Benjamin Naiman, Capt.  
25 Pinsker Str.  
Petah-Tiqva, Israel.

Petah-Tiqva, March 30-th, 1956.

Remington Arms Company, Inc.  
Ilion, N.Y., U.S.A.

FIG 3

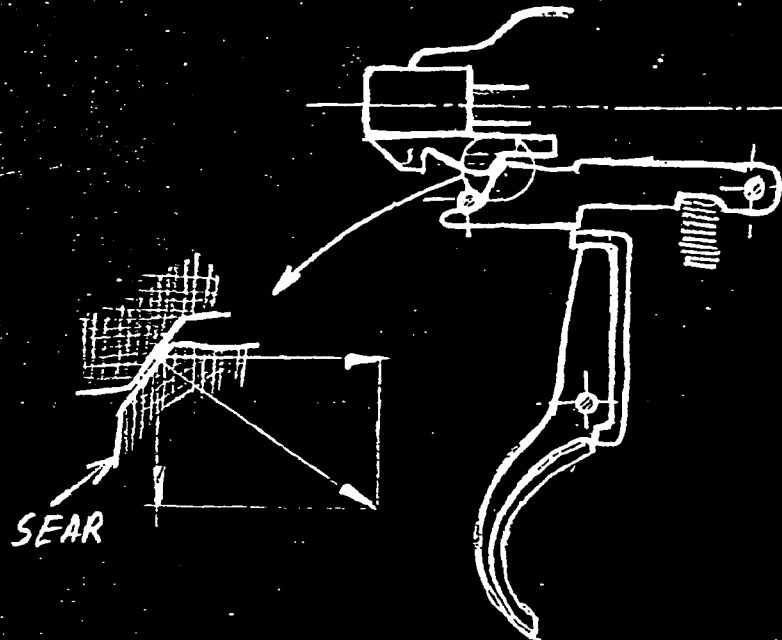
The disappointment came from the trigger action and here is the story: On the very day of the purchase, after several "dry shots" at home, the bolt got stuck and would not lock unless forced brutally.. The safety lever would not function. The stock removed, the surface of the firing pin head was found to be riding over the sear surface. On further dismantling of the trigger mechanism, the cause was revealed: the trigger with the connector have sunk. I cannot state the cause; it was due, presumably to either the poor quality of the trigger alloy or to liberal tolerances (pins placings and such). Fig. No. 3 will illustrate the above.

FIG 4

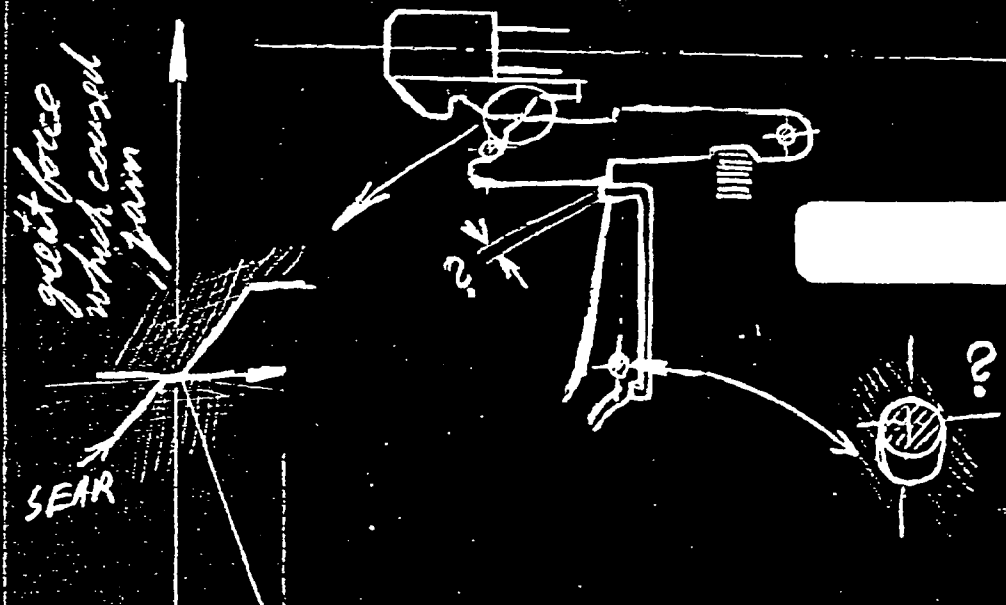
I had to order a new connector with a thicker head and, seeing no reason why it should not be connected to the trigger, I fixed the two bodies together by means of a 1/8" screw. The latter arrangement enabled me to replace the original heavy trigger spring by a lighter one aiming for a lighter pull. Please inform me whether you approve of the above. The click adjustment of the trigger is most convenient but unscrewing the trigger adjusting screw too much, causes the "trigger adjusting ball" to be pushed outside by the spring and removing of the stock becomes necessary. I suggest that the above be eliminated by addition of a thin pin-extension to the "trigger adjusting screw" (see fig. No.4). It proved successful on my rifle.
